SANDY SPRINGS
GEORGIA

P&Z STAFF REPORT

Board of Appeals Meeting, April 1, 2020

Case: **V20-0014—1425 N. Riverside Circle**
Staff Contact: Madalyn Smith (MSmith@SandySpringsGA.gov)
Report Date: March 12, 2020

Figure 1. Site plan with the river setback shown in blue and the sewer easement shown in red

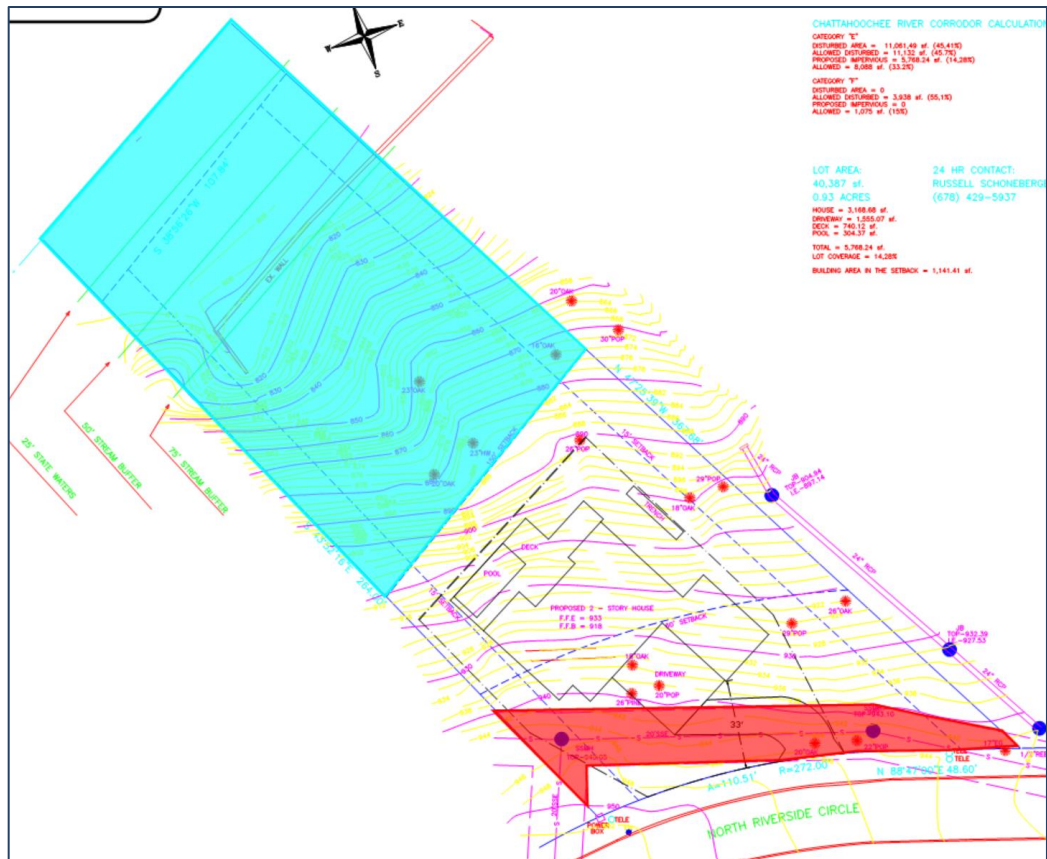
Finding: The subject lot has significant challenges due to extreme topography. The lot drops down towards the Chattahoochee River at an average slope of 36%, which is very steep and is designated as an area of Steep Slopes by the Development Code (Sec. 9.4.2.E.). The lot gets progressively steeper behind the setback. Due to the slope, the application of the 60-foot setback would require clearing and land disturbance that is much more extensive and intrusive; both clearing and grading are discouraged in the River Corridor.

Approximately half the lot is unbuildable due to the 150-foot setback from the Chattahoochee required by the River Protection Act. In addition, a sewer easement runs across the front of the property that would not allow the larger retaining walls that are required for a longer driveway. For these reasons, Staff finds that there are extraordinary and exceptional conditions due to the topography of the site.

Following review, and based on the findings, Staff recommends **Approval** of **Variance** V20-0014, request for a Variance from Sec. 2.3.2.A. to allow a house to encroach 27 feet into the required 60-foot minimum primary street building setback, subject to the following condition:

1. The intrusion into the primary street setback be limited to and substantially similar to that shown in the site plan, prepared by Alpha Land Services, received March 3, 2020

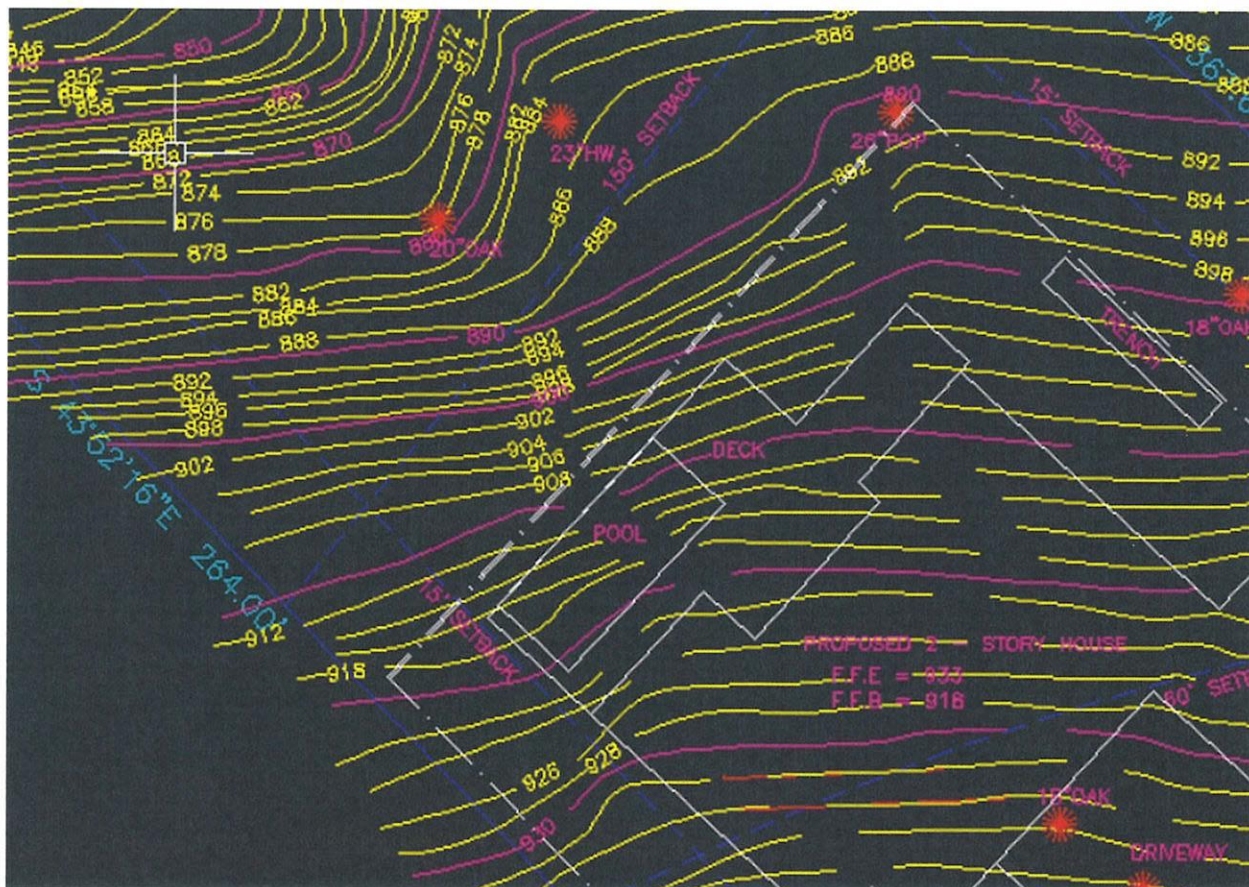
- i. This design also provides for a side entry garage that matches the design of the other homes on the street.
- h. In the image below you will see that from the elevation point of 910 it is sheer drop down 20 feet to 890 within the buildable area. This is a major hardship to have to build on a cliff face. Then it drops another 10ft very quickly. Note there is less than 40 ft of buildable depth to the lot that we can build on a before it drops off the cliff.
